RESPONSE TO COMMENTS

City of Miami Beach,
Wachovia – Alton Road
Response to Building Dept. Cmts.
Page 2 of 4

WACHOVIA - ALTON ROAD BRANCH
1901 ALTON ROAD
MIAMI BEACH, FLORIDA

DESCRIPTION OF WORK:	Construction of New Exterior ADA Ramp; Relocation of ATM & AHD Equipment; Minor Interior Remodel to Create a New ATM Room.
BUILDING CODES:	FLORIDA BUILDING CODE, 2004 EDITION 2004 FLORIDA FIRE PREVENTION CODE NFPA 101, LIFE SAFETY CODE, 2003 EDITION
BUILDING TYPE:	TYPE IIIB
CLASSIFICATION OF WORK:	ALTERATION - LEVEL 2
OCCUPANCY TYPE:	BUSINESS
OVERALL EXISTING BUILDING SQUARE FOOTAGE:	6,085 SF
OCCUPANT LOAD:	1 PERSON/100 S.F. GROSS (6,085 SF/100 SF = 61 PEOPLE)

3 ATM ELEVATION

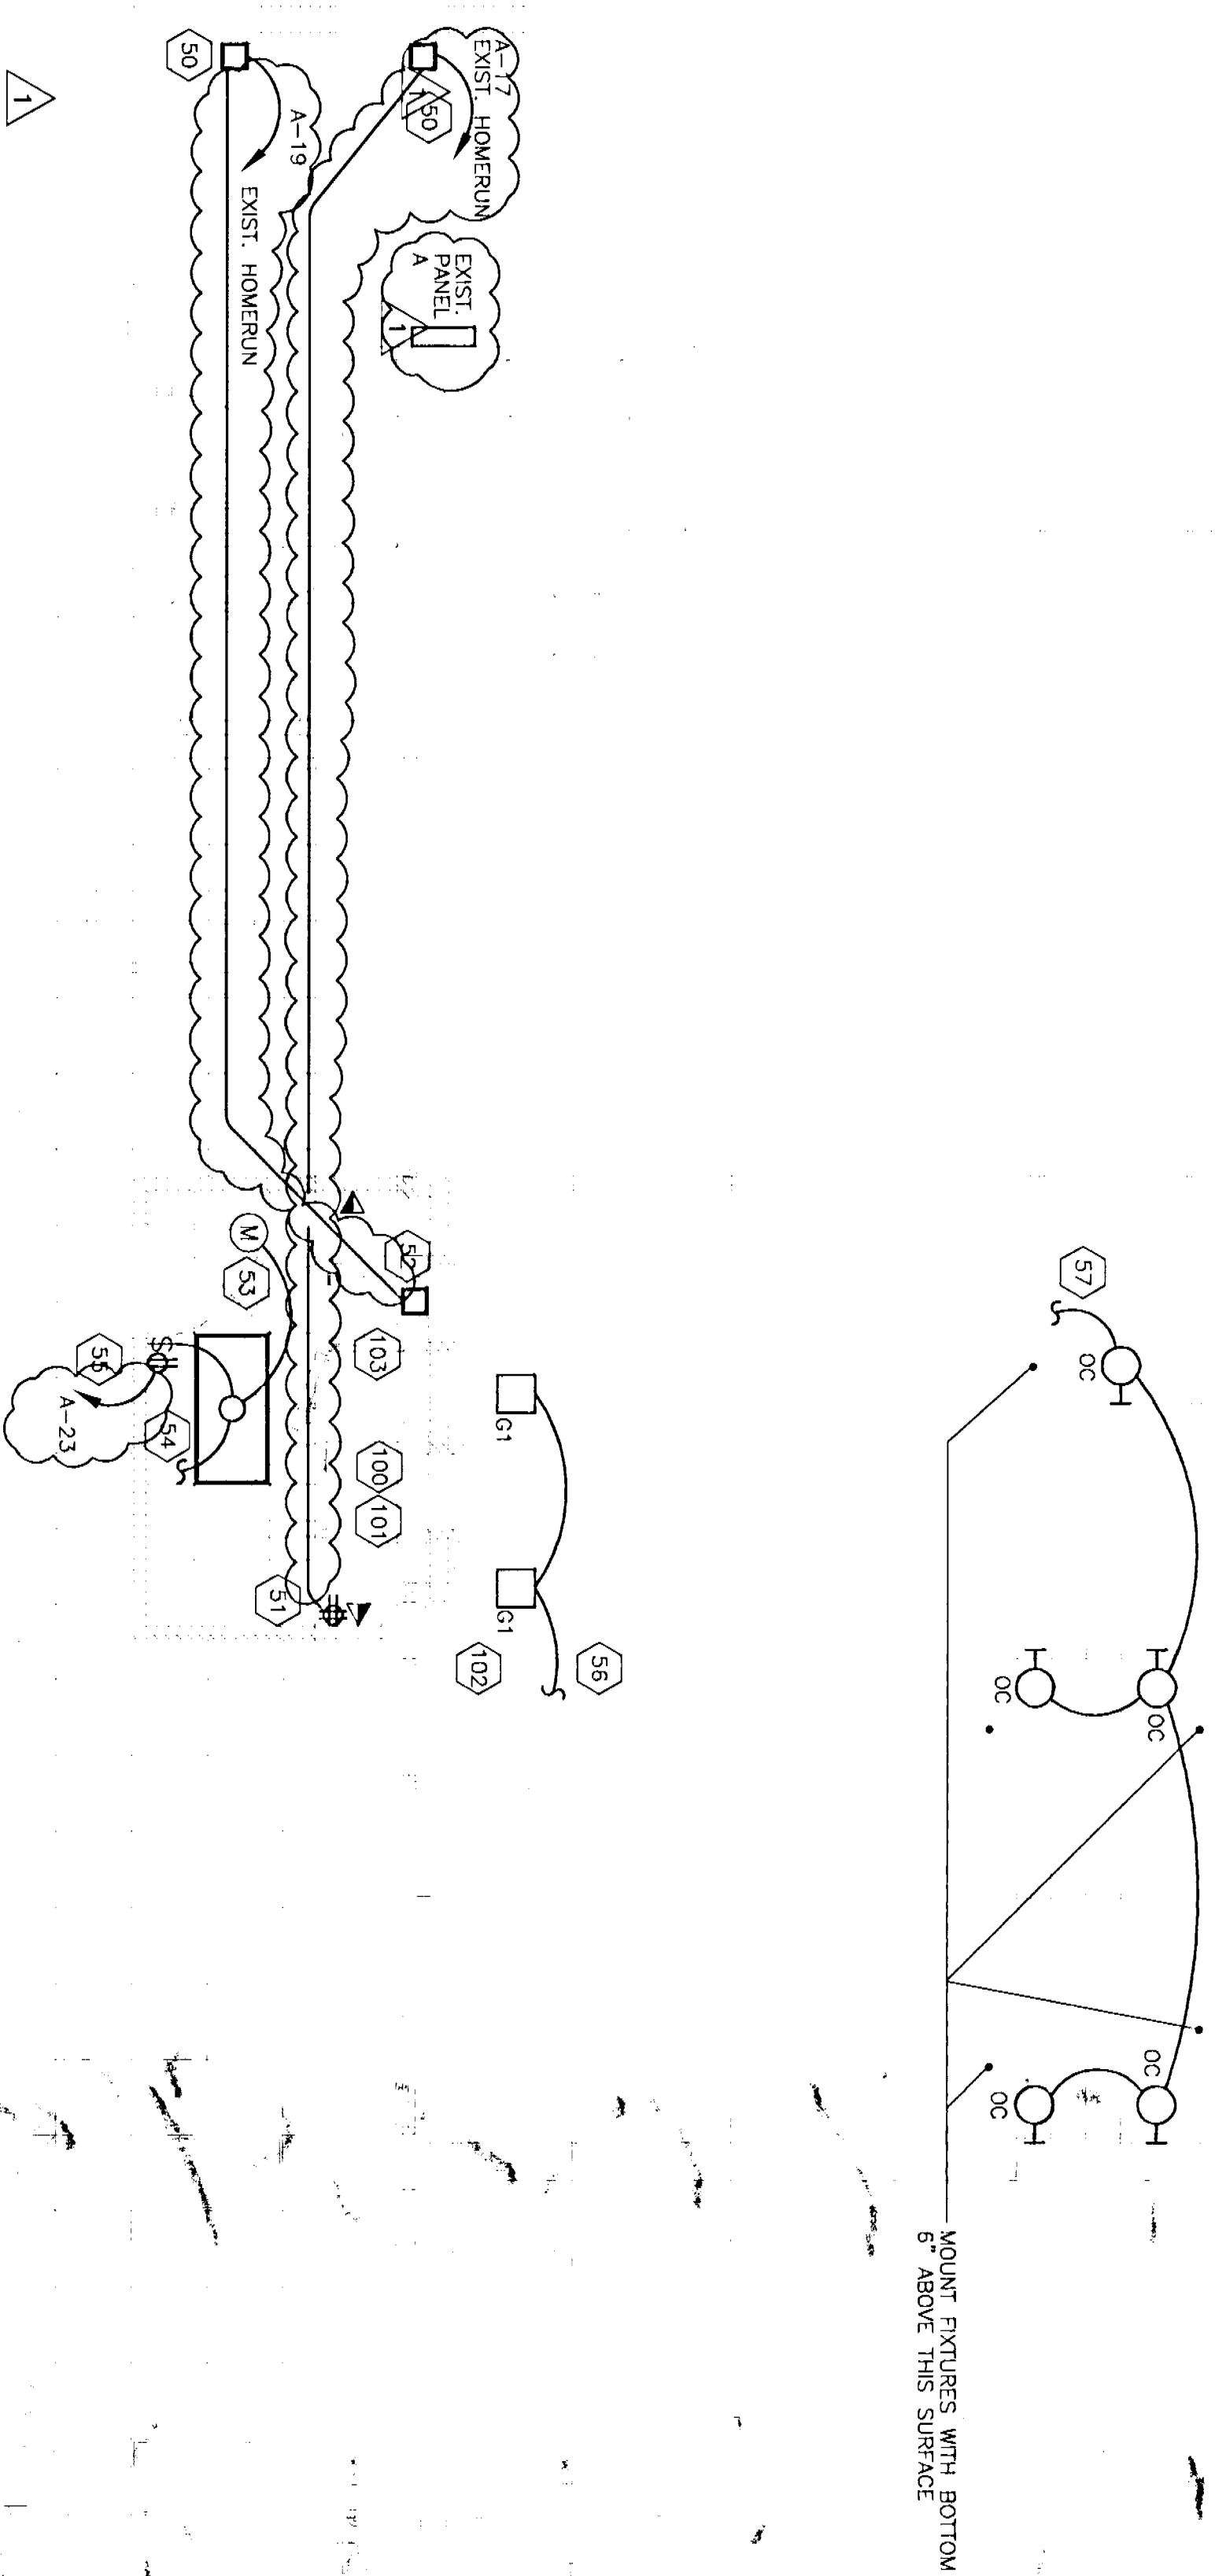
Show ATM reachable ranges.

Refer to revised Sheet A5.1 for the elevation of both the ATM and AHD equipment with the applicable heights.
